Subject: 2024 Annual Dam Safety Inspection – Processed Kimberlite Mine Workings Facility, A418 Underground Hydrostatic Plugs

TECHNICAL MEMORANDUM

Reference No. CA0035294.6784-2557-TM-Rev0-7000

A418 UNDERGROUND HYDROSTATIC BULKHEAD SITE INSPECTION – 9130 AND 9080 LEVELS

Figure 3: 9080-Level Total Earth Pressure Cells

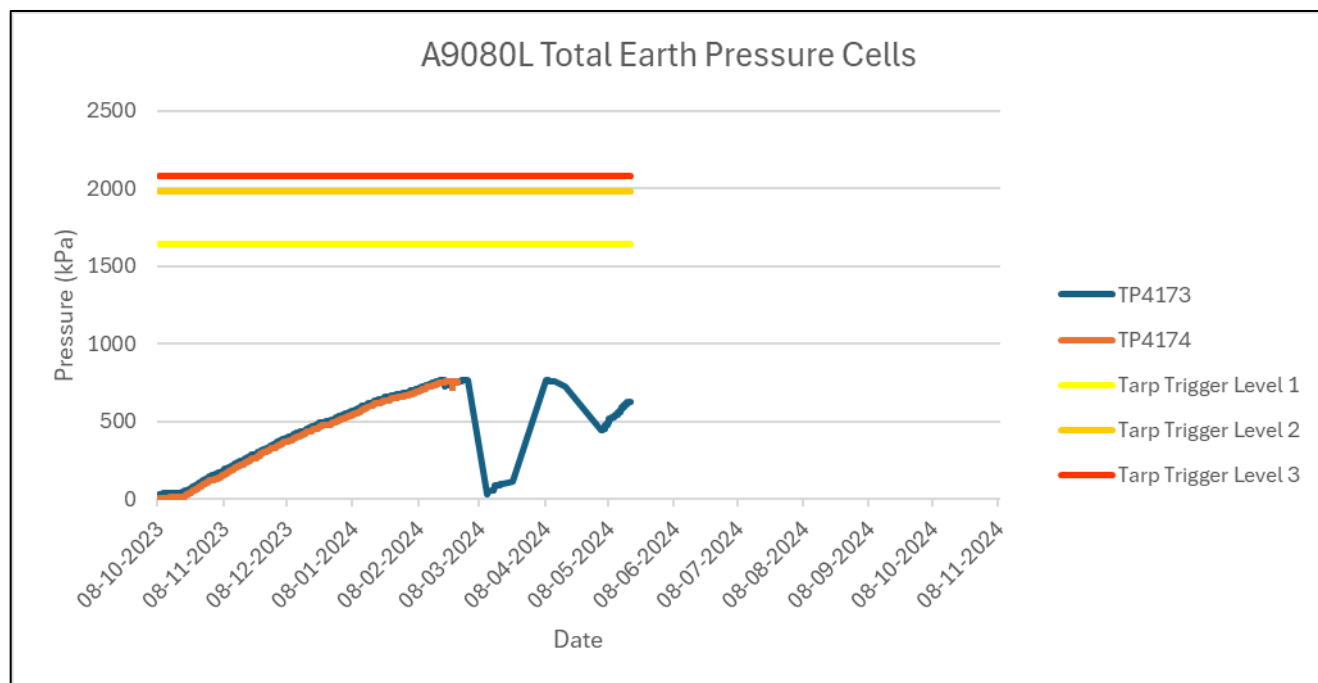
Two TEPCs (PC9080-01 and PC9080-02) were installed on the bulkhead to measure the total pressure applied to the bulkhead from the water and FPK slurry (Figure 3). PC9080-01 stopped reading on February 25, 2024, while PC9080-02 stopped reading on March 2, 2024, due to pressures exceeding the capacity of the sensor. The loss of these pressure cells means the pressure applied to the bulkheads from the FPK slurry cannot be measured. The maximum pressure recorded was 758.1 kPa and 764.8 kPa on PC9080-01 and PC9080-02, respectively.

The five TEPCs have all stopped reading pressures due to the applied pressure exceeding the capacity of the installed instruments, and the applied load to the bulkheads from the FPK Slurry cannot be monitored. DDMI initiated the replacement of these TEPCs with higher pressure range TEPCs, completing the installation of a replacement TEPC and piezometer, into the 9080-level drift at the beginning of October 2024. Monitoring data for these instruments are being collected routinely and will be reported in the 2025 annual inspection report.

Figure 7: 9130-Level Total Earth Pressure Cells

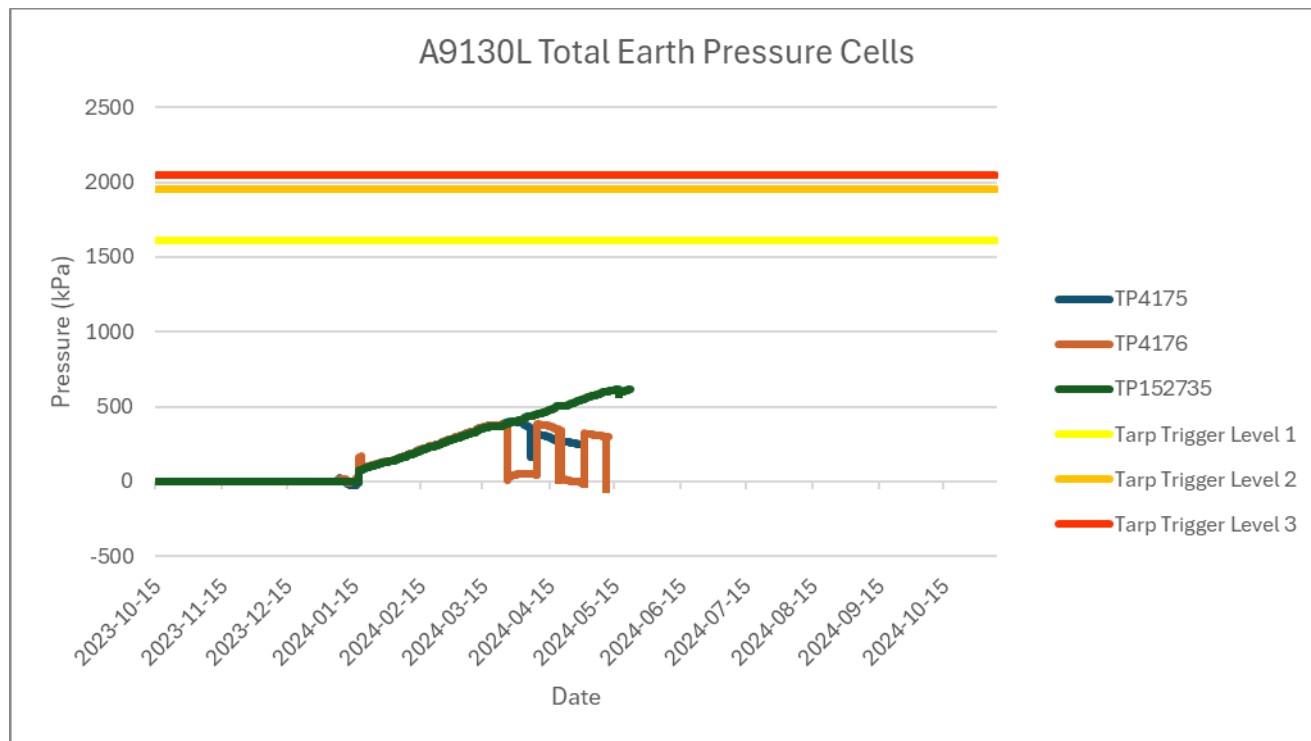
Three TEPCs (TP4175, TP4176, and TP152735) were installed on the bulkhead to measure the total pressure applied to the bulkhead from the water and FPK slurry (Figure 7). TP4175 stopped reading on March 28, 2024, TP4176 stopped on March 25, 2024, while TP152735 stopped reading on May 21, 2024 due to pressures exceeding the capacity of the sensor. The loss of these pressure cells means the pressure applied to the bulkheads from the PK slurry cannot be measured. The maximum pressure recorded was 397.9 kPa, 384.2 kPa, and 617.8 kPa for TP4175, TP4176, and TP152735, respectively.

Figure 8: 9130-Level Strain Gauges

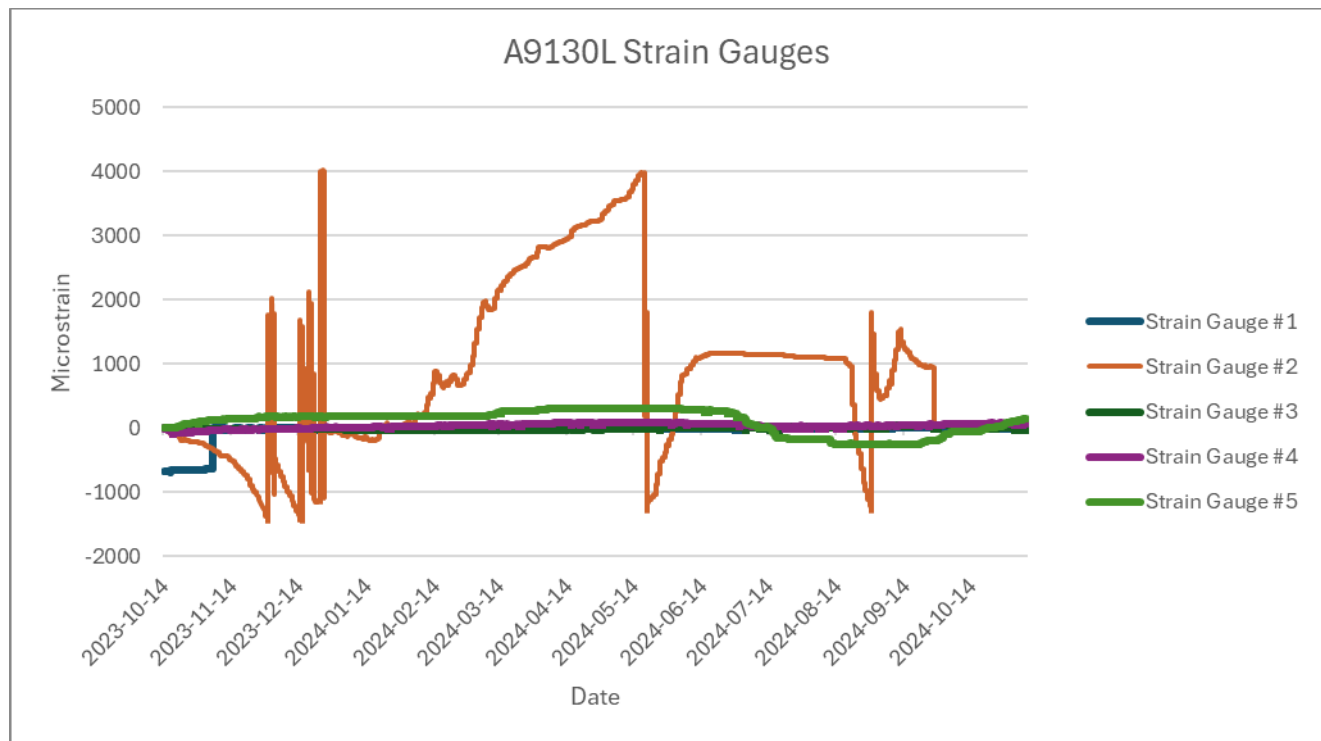
Five strain gauges, installed into the ribs and bulkhead, are used to monitor flexural stability and shearing of the bulkhead. Strain Gauge #2 has historically provided unreliable readings, with strain reaching and exceeding the Level 2 value of 3,000 $\mu\epsilon$ before dropping sharply (Figure 8). Due to reliability concerns for this instrument, DDML replaced the gauge in February 2024; however, the new instrument has continued to record erroneous results.

The strain gauges have generally shown minimal microstrain as a result of flexural or punching movement of the bulkhead. The exception is that Strain Gauge #2 on the 9130-level bulkhead has had erratic readings since it was installed. After replacing the instrument, data continued to show erroneous readings. During the site inspection, it was identified that one side of the strain gauge was installed into a piece of timber, which had remained after construction of the bulkheads.

ID	Location	Identified Issue	Recommendation	Priority	Recommended Timing for Action
A418-2024-02	9080 Bulkhead	Strain Gauge #2 has an erratic data output and the results cannot be relied upon.	The Strain Gauge #2 on the 9130-level bulkhead is to be repositioned such that the pins of the strain gauge are installed into concrete.	3	Q1 2025
A418-2024-03	9130 Bulkhead (wet side)	Total Earth Pressure Cell on the 9080 and 9130 Bulkheads have failed due to over pressure on the sensor.	Calibration and monitoring of the new TEPC and piezometer, installed into the 9080-level drift, should continue to be prioritized.	4	Q1 2025
